Access Compliance Report

Public Rights-of-Way

(Curb Ramps)

Intersection ID: 29271	Main Street: IRON_BRIGADE_LN	Cross Street: LAKOTA_CT	Location: W
ADA ID: DBEA3E02709C	Ramp Type: PerpDiag	Initial Pass/Fail: Fail	Overall Compliance: No
Severity Score: 8.75			
Codes/Mitigation Info/Possible Solution		Field Measurements/Component Compliance

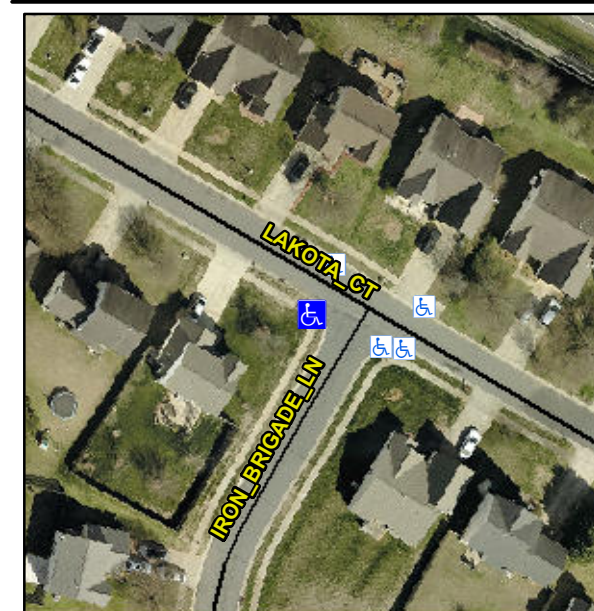
Not Found, R304.5.1

Compliance	Description	Data	Compliance	Description	Data
N/A	Ramp Length (in)	46.0	Yes	Ramp Slope (%)	6.6
No	Ramp Width (in)	38.0	Yes	Ramp XSlope (%)	1.3
N/A	Flare Type LT	N/A	N/A	Flare Type RT	N/A
N/A	Flare Slope LT (%)	N/A	N/A	Flare Slope RT (%)	N/A
N/A	Flare Traversable LT?	N/A	N/A	Flare Traversable RT?	N/A
N/A	Landing Length (in)	N/A	N/A	DWS Provided?	N/A
N/A	Landing Width (in)	N/A	N/A	DWS Contrast?	N/A
N/A	Landing Slope (%)	N/A	N/A	DWS Length (in)	N/A
N/A	Landing X Slope (%)	N/A	N/A	DWS Full Width?	N/A
N/A	Landing Curb? (Y/N)	N/A	N/A	DWS Offset (in)	N/A
N/A	Shared Landing?	N/A			
N/A	Gutter Ponding?	N/A	N/A	Gutter Slope (%)	N/A
N/A	Gutter Lip Ht (in)	N/A	N/A	Gutter X Slope (%)	N/A
N/A	Painted X Walk1?	No	N/A	Painted X Walk2?	No
	X Walk 1 Direction	To S		X Walk 2 Direction	To N
N/A	X Walk 1 Width (in)	N/A	N/A	X Walk 2 Width (in)	N/A
	X Walk 1 Slope (%)	2.6		X Walk 2 Slope (%)	2.5
	X Walk 1 X Slope (%)	2.1		X Walk 2 X Slope (%)	2.3

Remove & Replace Curb Ramp With Two New Directional Ramps or Equivalent.
